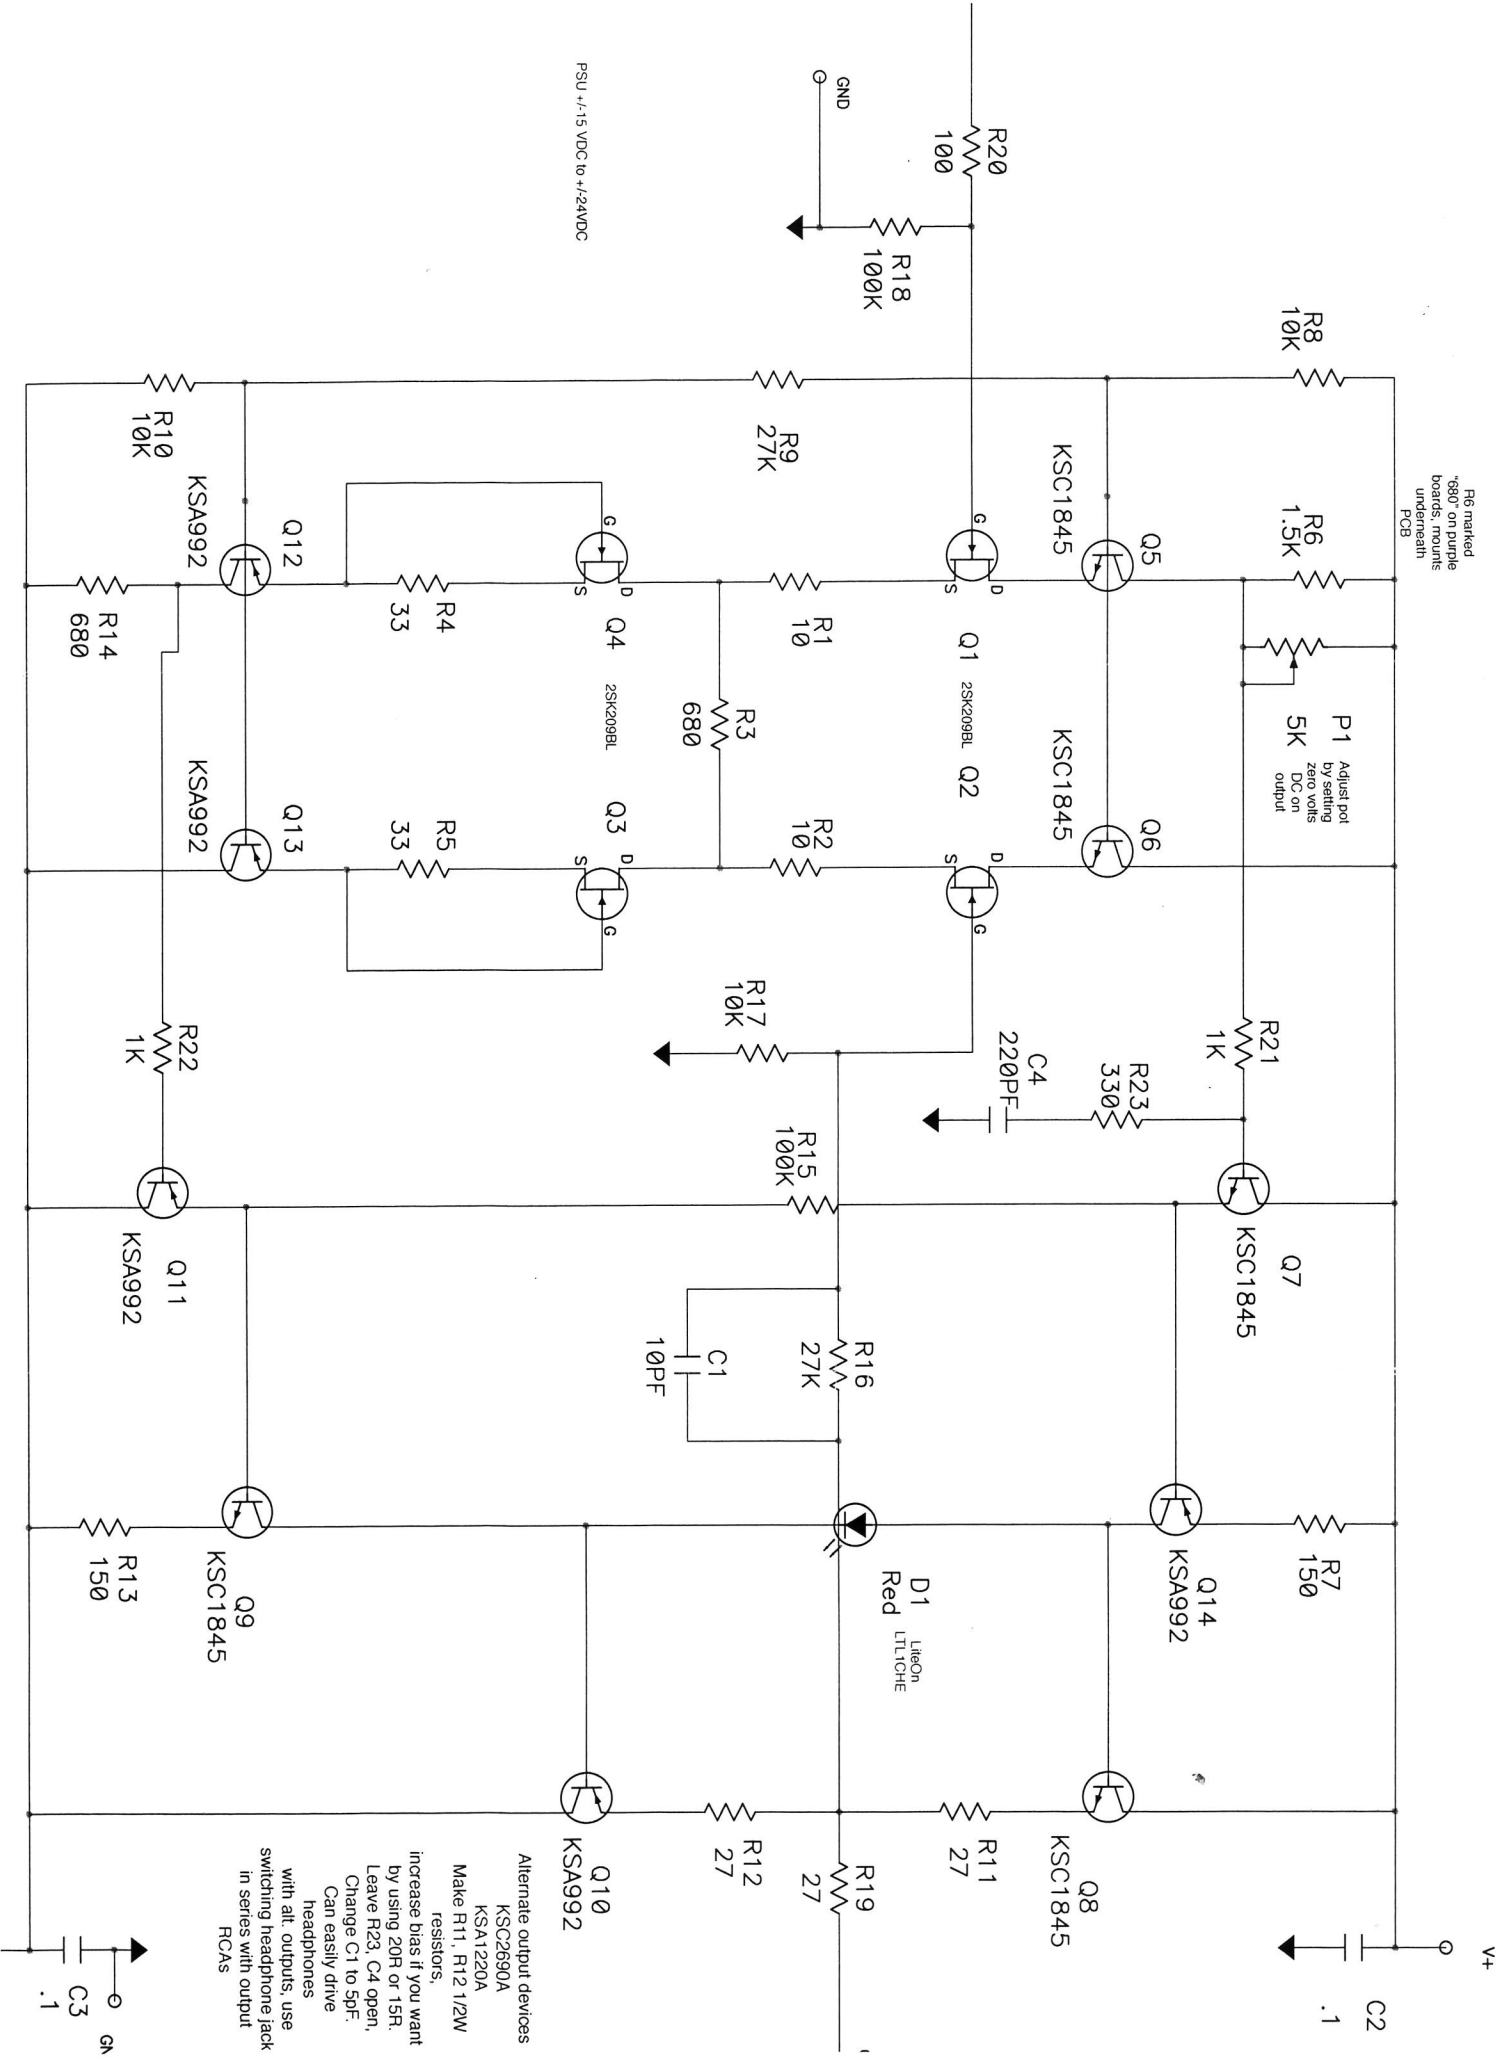
R6 marked  
"680" on purple  
boards, mounts  
underneath  
PCB

Alternate output devices  
KSC2690A  
KSA1220A  
Make R11, R12 1/2W  
resistors.  
increase bias if you want  
by using 20R or 15R.  
Leave R23, C4 open.  
Change C1 to 5pF.  
Can easily drive  
headphones  
with alt. outputs, use  
switching headphone jack  
in series with output  
RCAS
